Wind Noise from Front Side Glass

Section Window/Glass

YEAR(S)	MODEL(S)	ADDITIONAL INFORMATION
2010	RX350

TSIB REVISION NOTICE

Figure 1.

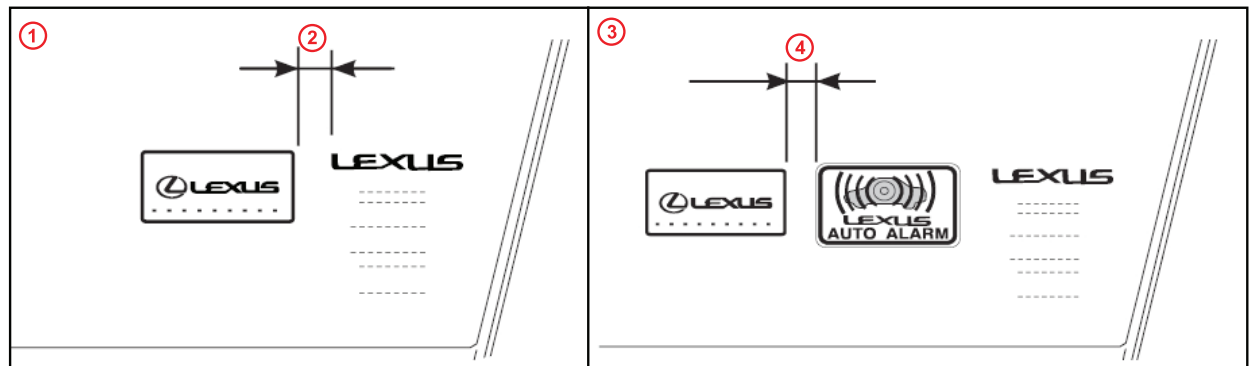
4. Install window labels in correct position.
 - A. Use household glass cleaner to clean the inside of the front door windows.
 - B. Use a piece of clear tape to lift the label from the protective backing.
 - C. Attach the label as shown in Figure 1.
 - D. Repeat steps A–C with the other window

NOTE
Compare original glass to new glass to make sure labels match.

1	How to Align to the Etching
2	10 mm

3	How to Align to Other Labels
4	1–5 mm

Figure 2.

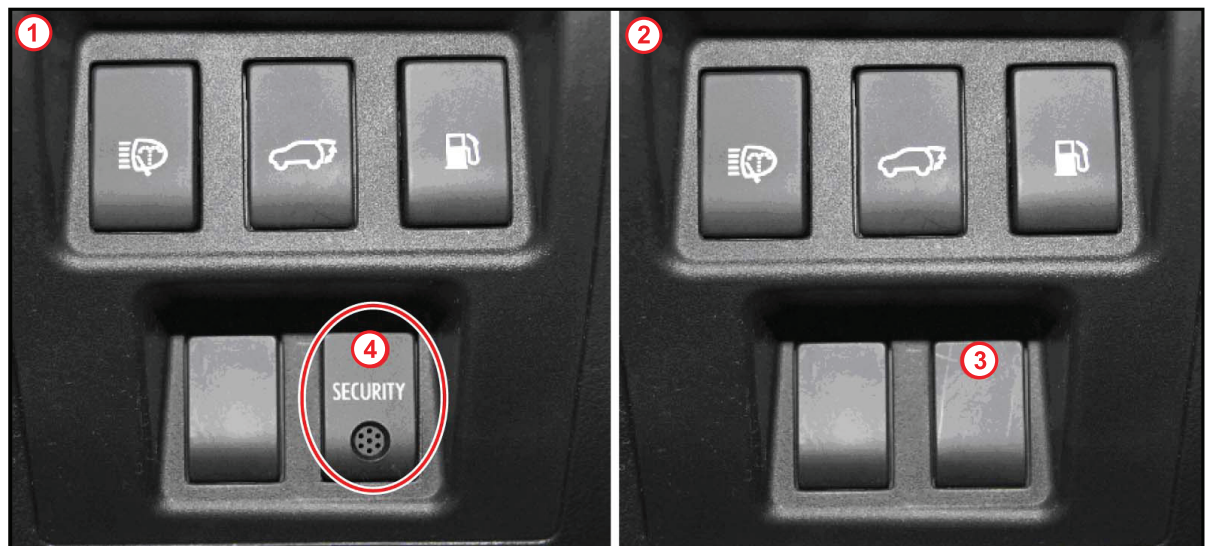
- A. For vehicles equipped with a Glass Breakage Sensor, the sensor position and/or system sensitivity will need to be calibrated for the new glass.
- B. Determine if the Glass Breakage Sensor was installed at the Factory or as a Post Production Option (PPO)/ Dealer Installed Option (DIO).

- C. If Factory Installed, follow the PPO/DIO Glass Breakage Sensor Accessory Installation Procedure in TIS to adjust GBS system sensitivity for acoustic glass.

Figure 3.

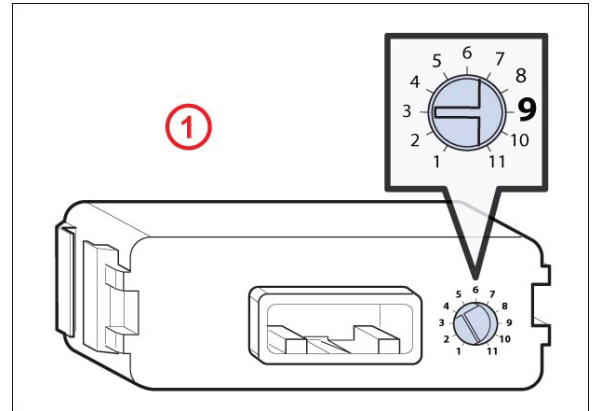
- D. If PPO/DIO, follow the PPO/DIO Glass Breakage Sensor Accessory Installation Procedure in TIS to adjust GBS system sensitivity and relocate the GBS microphone for acoustic glass.

System Sensitivity should be set to 9.

1 Vehicles with Acoustic Windows Only
